City of Plymouth Planning Commission Regular Meeting Agenda

Wednesday, May 12, 2021 - 7:00 p.m.

MEMORANDUM

Site Plan Review For Plymouth, Michigan

LANDSCAPE DESIGN

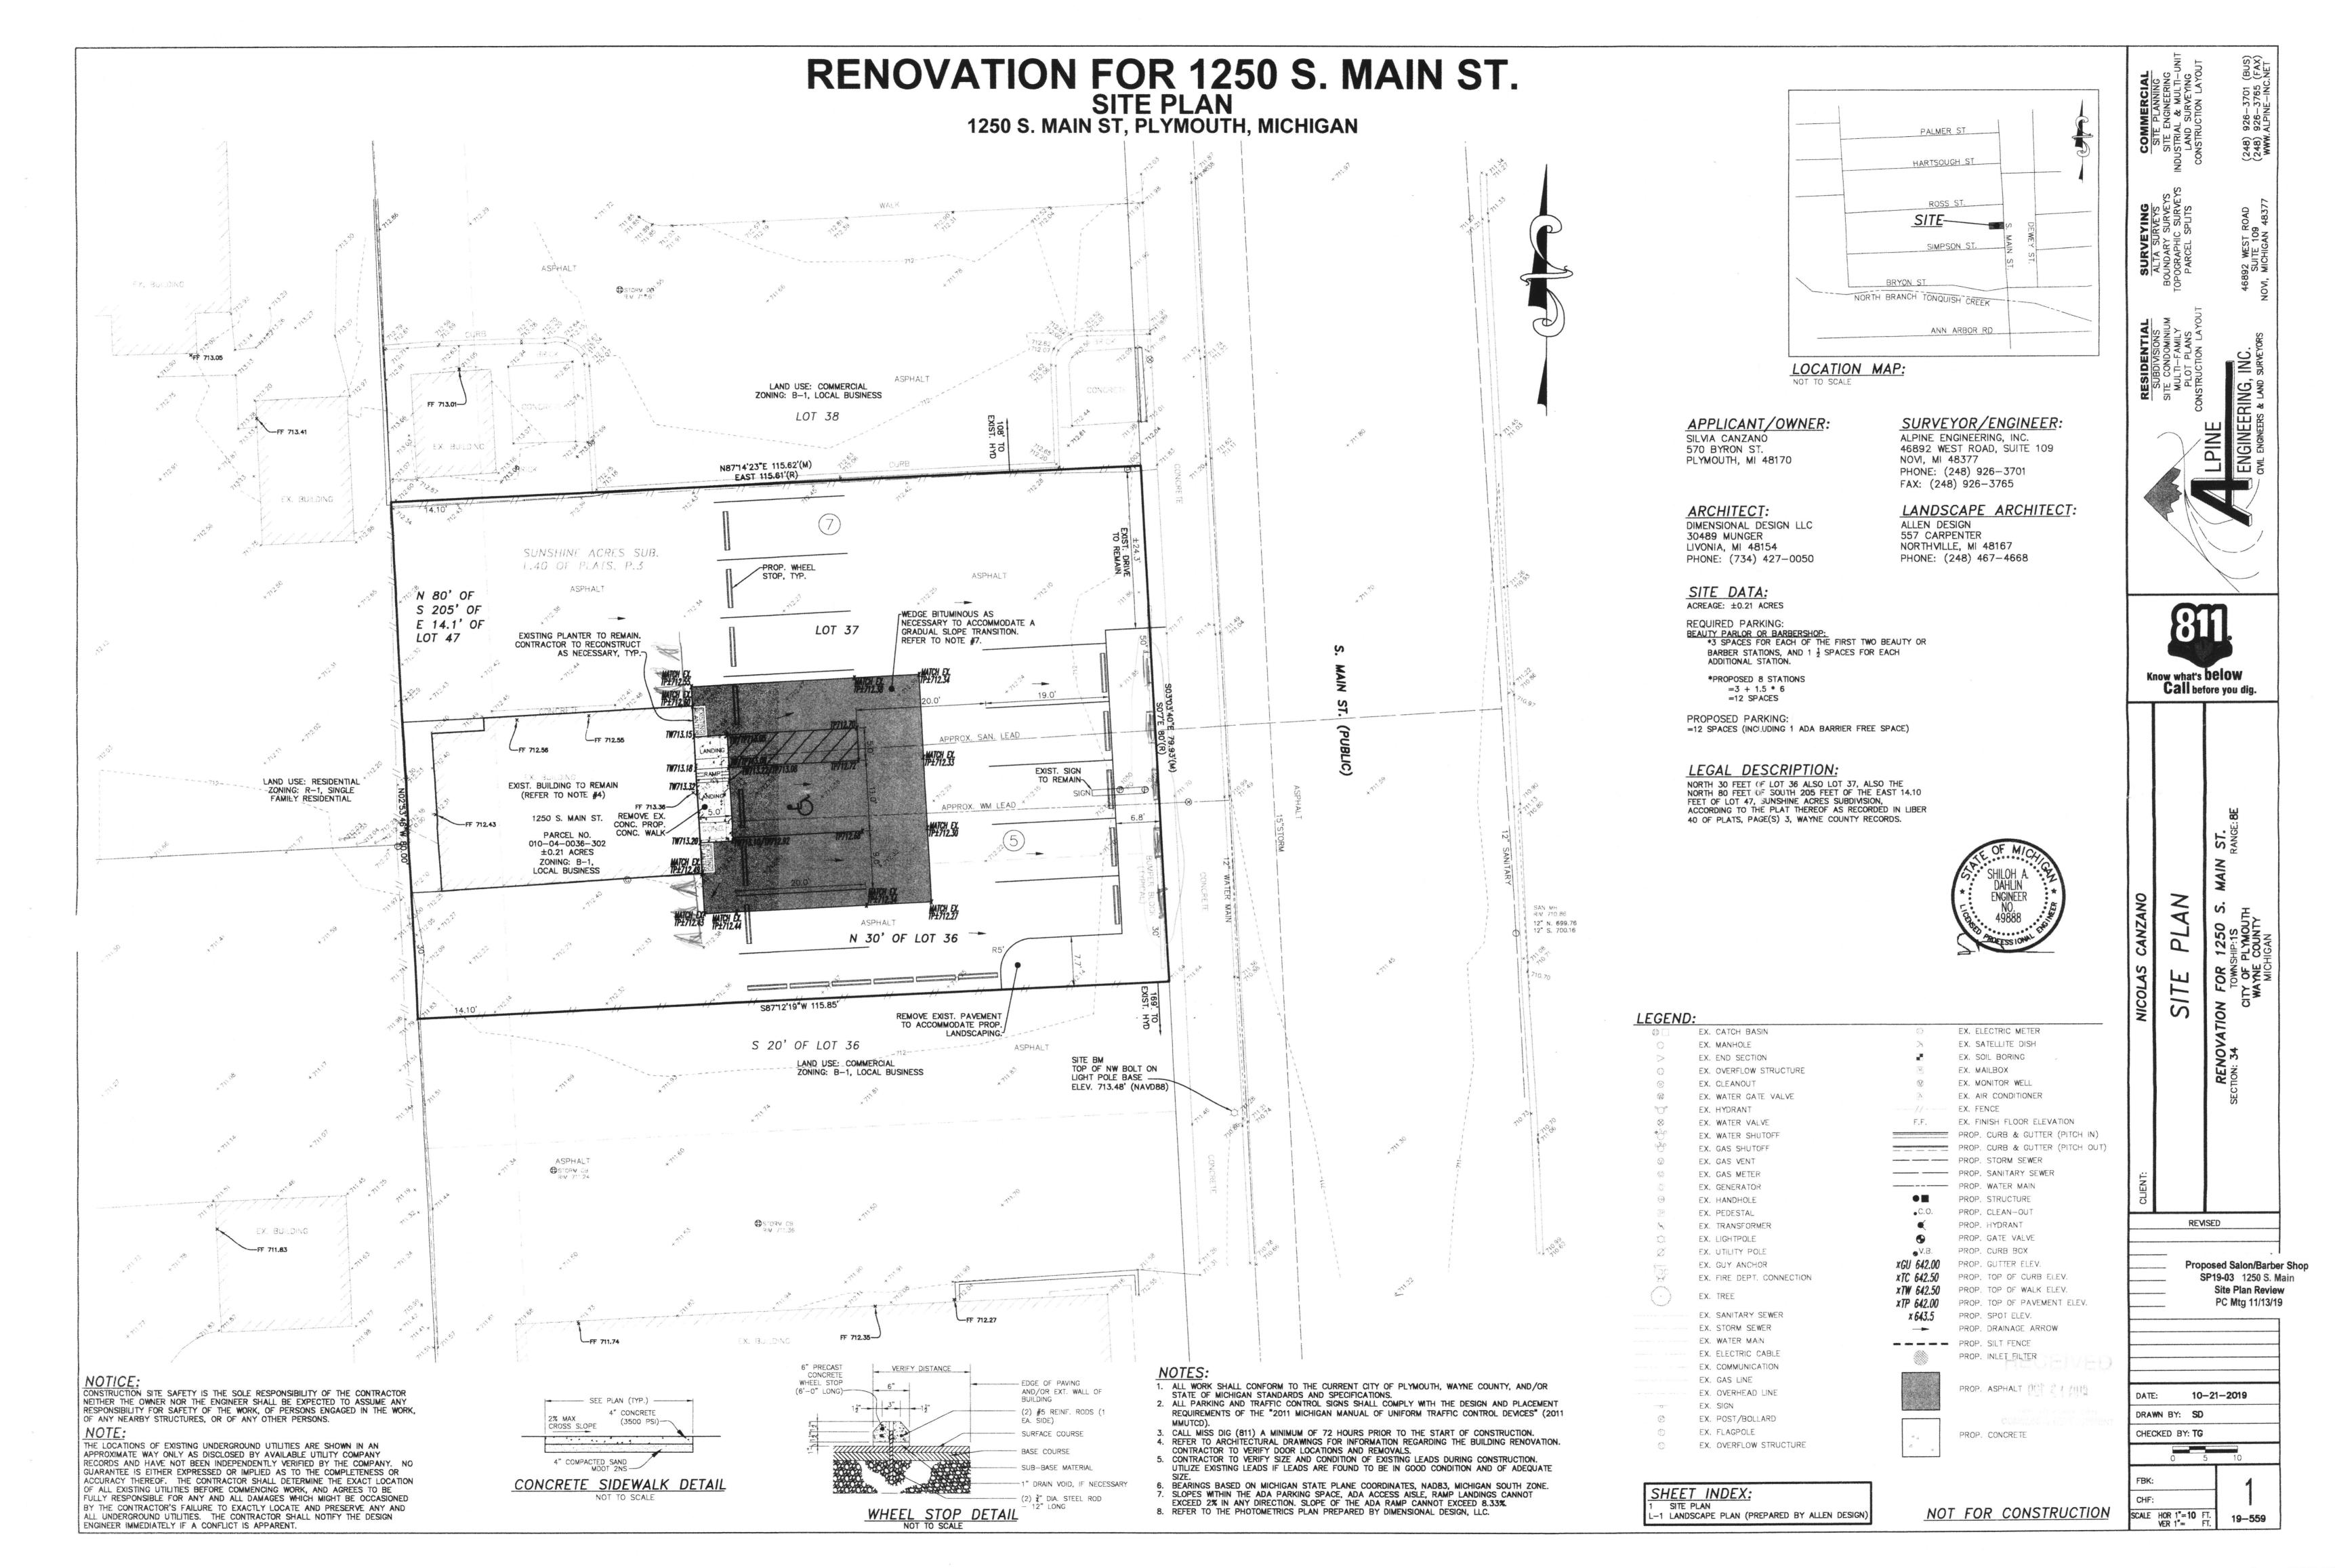
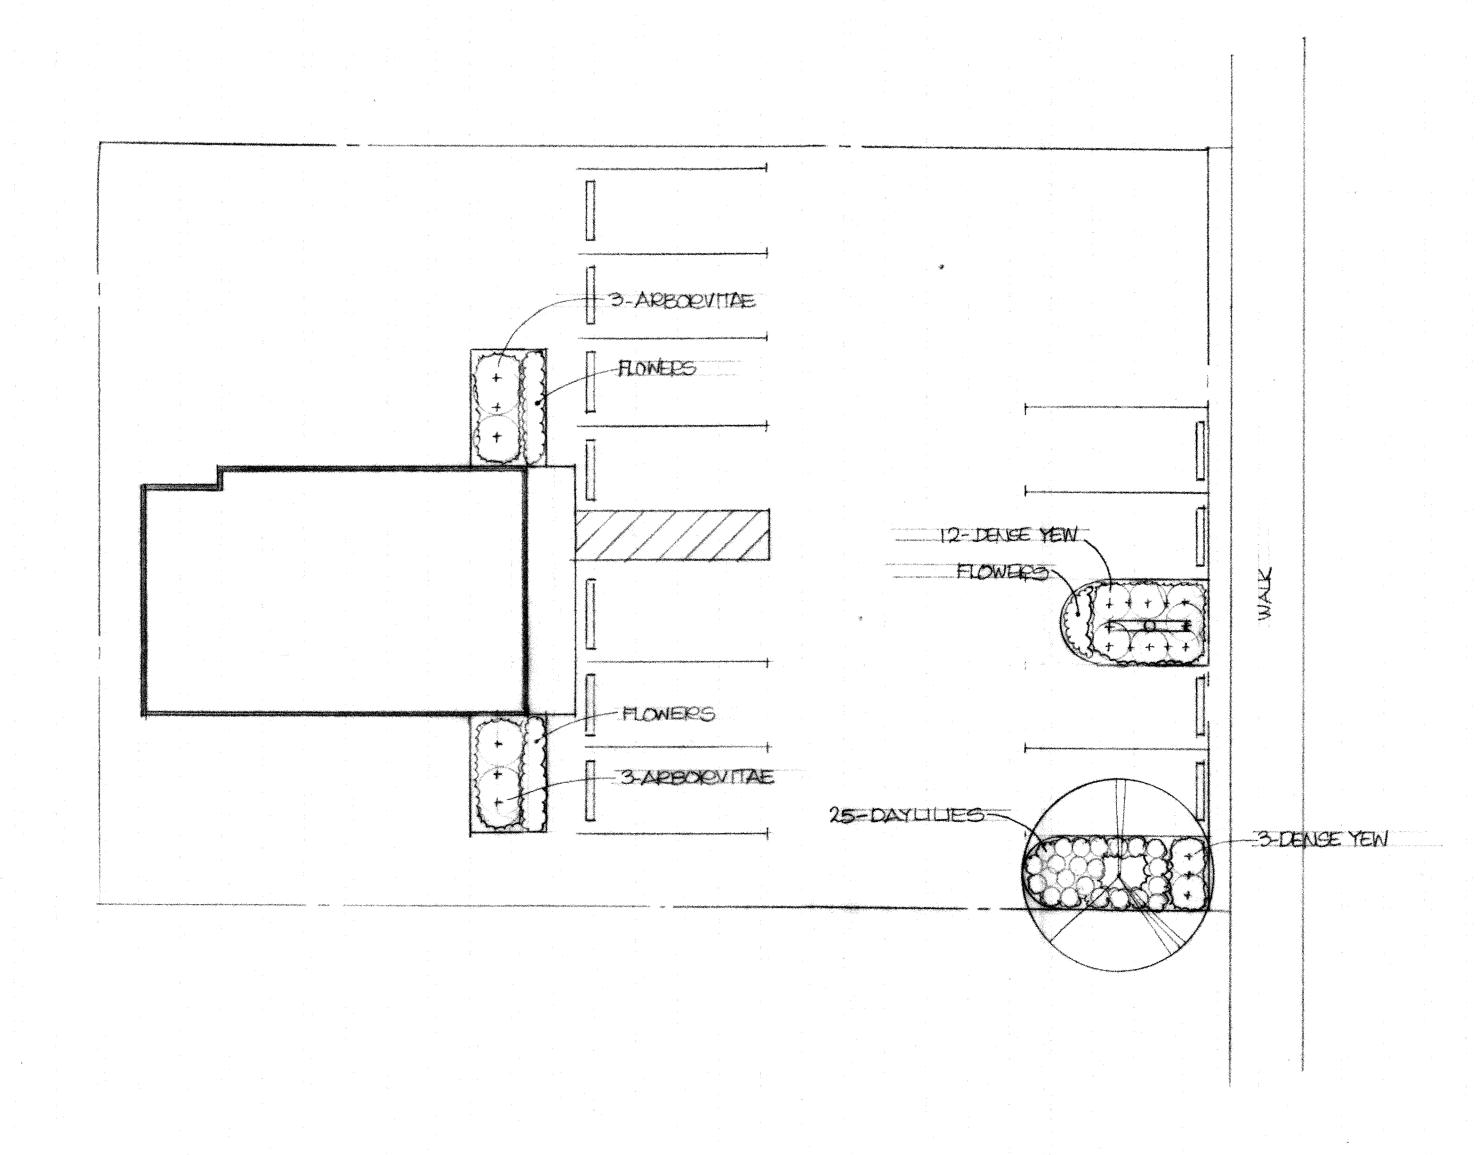
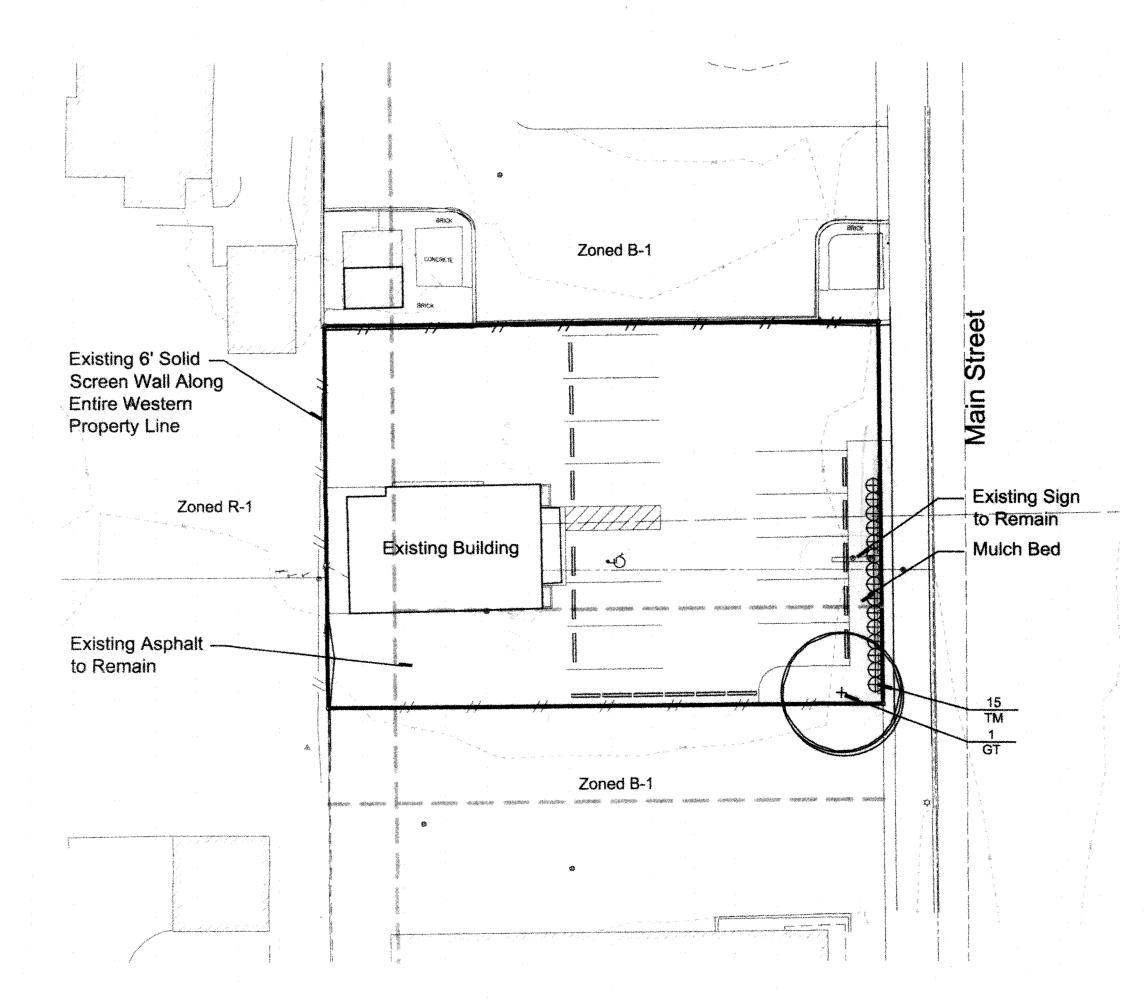
- 1. The perpendicular orientation of the landscape islands does not screen the parking lot as well as the previous proposal.
- 2. The number of shrubs overall is sufficient; however, as described above, the purpose of the shrub planting is to screen the parking lot from the street. While attractive, planting shrubs on the north and side sides of the building does not accomplish this goal. Also, we assume the shrubs on the north and south sides of the building are in pots or planters? Please confirm.

- 3. The ordinance requires three trees in this parking lot. The revised plan shows one tree; two trees need to be provided. The species of proposed tree needs to be identified on the plans. In addition, the size of all the proposed plant material needs to be specified on the Landscape Plan.

- 4. Regarding plant species, Arborvitae are susceptible to salt spray in the winter. We would recommend a shrub that is more salt-tolerant of these conditions, such as *Rosa rugosa*. Also not evergreen, "Gro Low" Sumac is salt tolerant, fairly maintenance-free, and has nice fall color. The applicant should address this or other alternatives, but the species should not be susceptible to salt spray.

Items to be Addressed: 1. Parking lot screening is insufficient in number of shrubs and trees. 2. Are shrubs proposed on north and south sides of building in pots or planters? 3. Landscape plan to show species of tree, and size of all plant material at time of planting. 4. Alternative species to Arborvitae that are tolerant of salt spray. 5. Applicant to revise Landscape Plan so that it meets ordinance requirements. 6. Applicant seek variance from Board of Zoning appeals to install alternative landscaping that does not meet ordinance requirements.
